STAFF REPORT
COMMUNITY DEVELOPMENT DEPARTMENT

HEARING DATE: 3/8/2022
TO: Mayor & City Council
FROM: Sonya Allen, Associate Planner
208-884-5533
SUBJECT: FP-2022-0007
Biltmore Estates No. 4
LOCATION: Generally located 1/4 mile south of W. Victory Rd. on the west side of S. Kentucky Way and a 1/2 mile west of S. Meridian Rd., in the north 1/2 of Section 25, T.3N., R.1W.

Final plat consisting of 33 building lots and 5 common lots on 10.85 acres of land in the R-4 zoning district for the fourth phase of Biltmore Estates Subdivision.

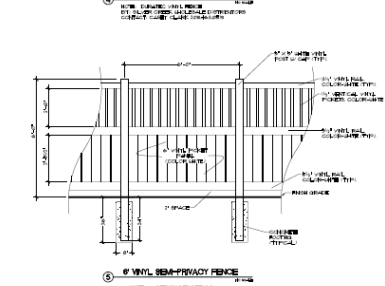
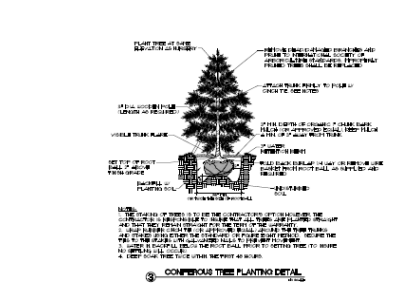
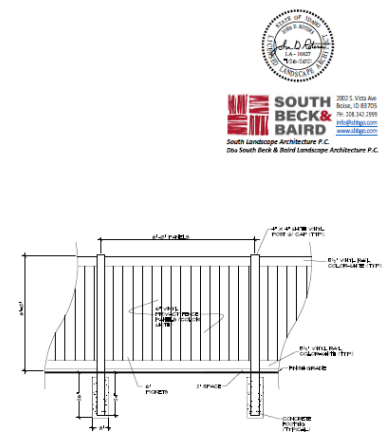
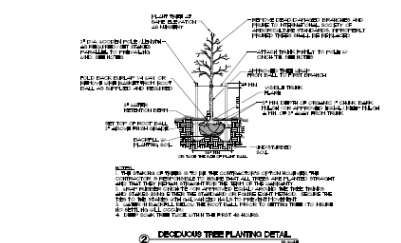
5. The landscape plan shown in Section V.C, dated 2/7/20, shall be revised as follows:
 - a. The total linear feet of parkways (excluding 26’ for each driveway) shall be included in the calculations table along with the required vs. proposed number of trees.

FIGURE D103.6
FIRE LANE SIGNS

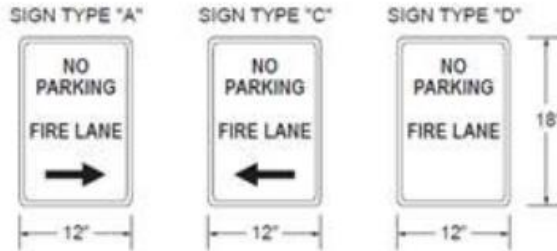
8. Submit a copy of the Ada County Street Name Review letter for the final plat with the final plat submittal for City Engineer signature.
9. Install “No Parking Fire Lane” signs in the cul-de-sac per requirement of the Fire Department in accord with ACHD standards. The bottom of the sign(s) should be 7-feet above the road/sidewalk surface and shall not be in the travel way. The sign(s) shall be installed about 6-inches to 1-foot behind the curbing or edge of pavement on a Telspar post. No other signs shall be approved:
